**UNITED STATES OF AMERICA
NUCLEAR REGULATORY COMMISSION
BEFORE THE PETITION REVIEW BOARD**

In the matter of
Pacific Gas and Electric Company
Diablo Canyon Nuclear Power Plant
Units 1 and 2

Docket Nos. 50-275, 50-323
Seismic Shutdown Petition
June 7, 2024

SUPPLEMENTAL DECLARATION OF PETER BIRD, Ph.D

**Mark-up (in red) by P. Bird, 2023 of
Figure 13-17 of SSC for DCPD
(PG&E, 2015)**

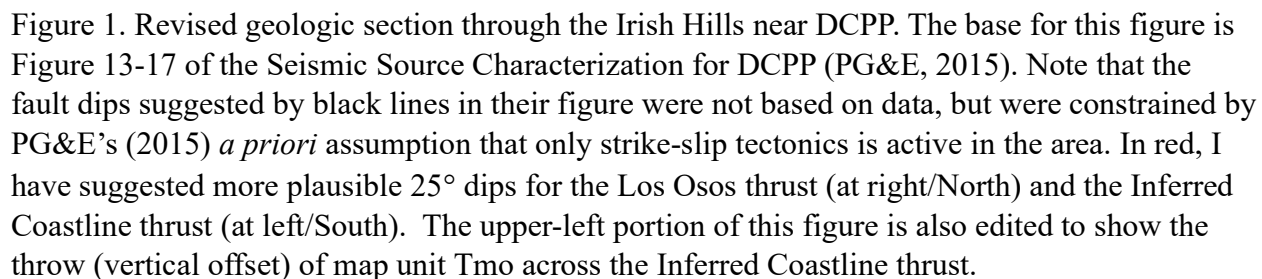
35. In addition, the FGMs in the SSC studies by PG&E (2015, 2015L, 2024) are contradicted by 3 critical facts:
- a) The sedimentary beds of the Miocene Obispo Formation (which were originally flat) have been offset vertically by 1.6~2.2 km at the southwest coastline of the Irish Hills, near DCP. This is documented in the geologic map of Figure 13-16 and the geologic section of Figure 13-17 of PG&E (2015), the latter of which Dr.

Bird modified to create Figure 1 (attached to this Supplementary Declaration). Neither the Shoreline nor the San Luis Bay faults in the FGMs from PG&E can explain this.
